T.I. no.: 2018 - 02 Updated: -	Topic: Schaerer Barista Software 1.7.1
--	---

Date: 08.02.2018	Priority	Need for action
Affected machines: Schaerer Barista	High	As soon as possible
From serial number: -	X Medium	X On next visit to the machine
As of date: -	Low	FYI only

Machine equipment – "Telemetry protocol" wheel

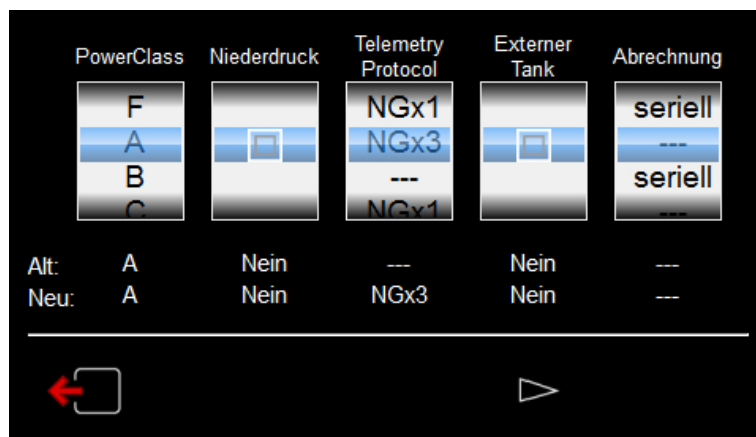
With the new software, the "RDA" checkbox has been changed to the "Telemetry protocol" wheel.

RDA can be activated in the "Telemetry protocol" wheel and the protocol type with which the RDA module should work can be set in the "Telemetry protocol" selection. Two protocol types are available for selection:

- NGx1, which corresponds to the existing functional scope with current RDA hardware.
- NGx3, which is planned for the future with extended functional scope and advanced RDA hardware.

After a software update, the NGx1 protocol setting was automatically made on machines for which RDA was already activated.
